MEJQ Housing & Sensor Slot Change

MEJQ series.

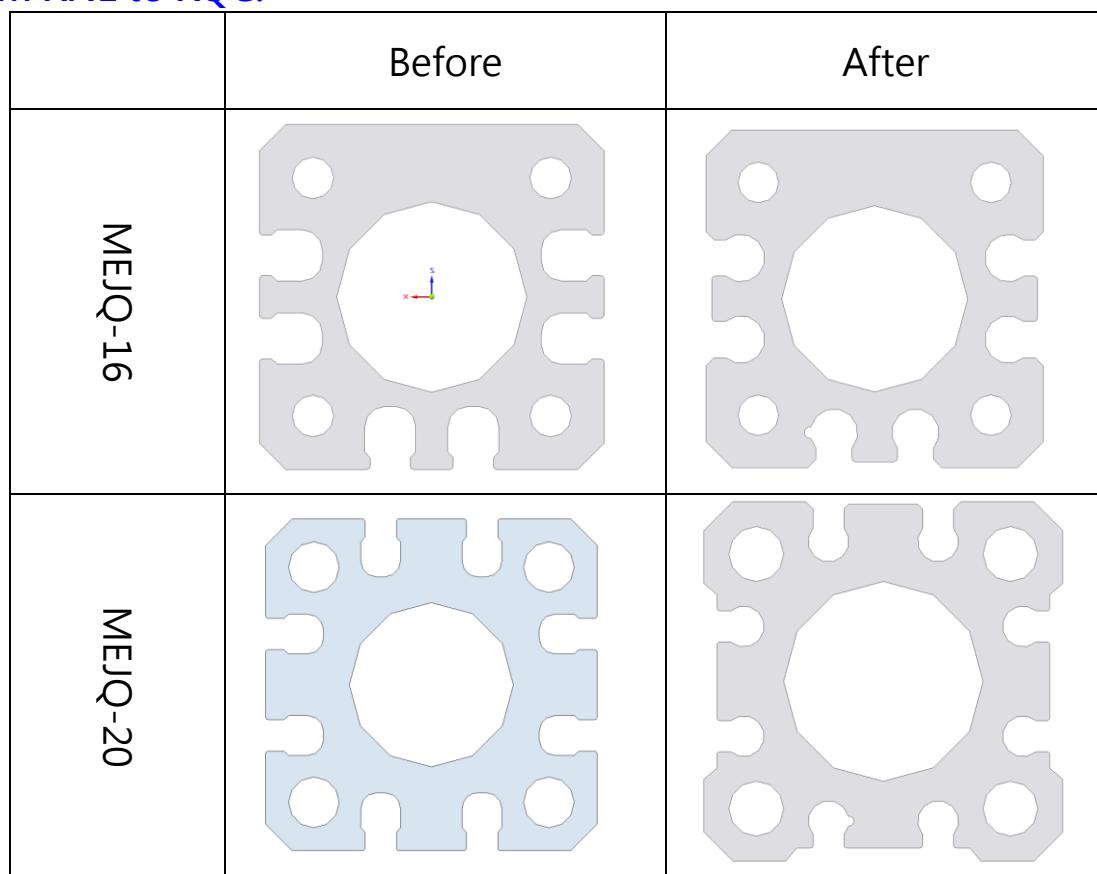
In order to condense the sensor variants.

Change the sensor slot shape of the housing and replace the sensor from RNE to RQC.
